## Access Compliance Report Public Rights-of-Way (Curb Ramps)

Intersection ID: 14846Main Street:HENLEY\_PLCross Street:S\_KINGS\_DRLocation:NEADA ID: 30D47866EE50Ramp Type:PerpInitial Pass/Fail:FailOverall Compliance:NoSeverity Score:10

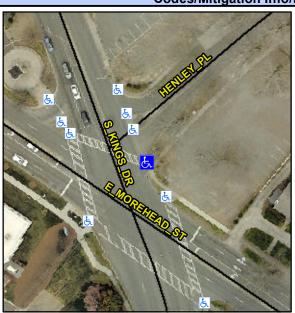
Not Found, R304.5.1, R304.5.3

Field Measurements/Component Compliance					
Compliance Description		Data	Compliance Description		Data
N/A	Ramp Length (in)	55.0	Yes	Ramp Slope (%)	6.2
No	Ramp Width (in)	47.0	No	Ramp XSlope (%)	4.0
N/A	Flare Type LT	N/A	N/A	Flare Type RT	N/A
N/A	Flare Slope LT (%)	N/A	N/A	Flare Slope RT (%)	N/A
N/A	Flare Traversable LT?	N/A	N/A	Flare Traversable RT?	N/A
N/A	Landing Length (in)	N/A	N/A	DWS Provided?	N/A
N/A	Landing Width (in)	N/A	N/A	DWS Contrast?	N/A
N/A	Landing Slope (%)	N/A	N/A	DWS Length (in)	N/A
N/A	Landing X Slope (%)	N/A	N/A	DWS Full Width?	N/A
N/A	Landing Curb? (Y/N)	N/A	N/A	DWS Offset (in)	N/A
N/A	Shared Landing?	N/A			
N/A	Gutter Ponding?	N/A	N/A	Gutter Slope (%)	N/A
N/A	Gutter Lip Ht (in)	N/A	N/A	Gutter X Slope (%)	N/A
N/A	Painted X Walk1?	Yes	N/A	Painted X Walk2?	N/A
	X Walk 1 Direction	To NW		X Walk 2 Direction	N/A
N/A	X Walk 1 Width (in)	84.0	N/A	X Walk 2 Width (in)	N/A
	X Walk 1 Slope (%)	1.2		X Walk 2 Slope (%)	N/A

Remove & Replace Entire Ramp.
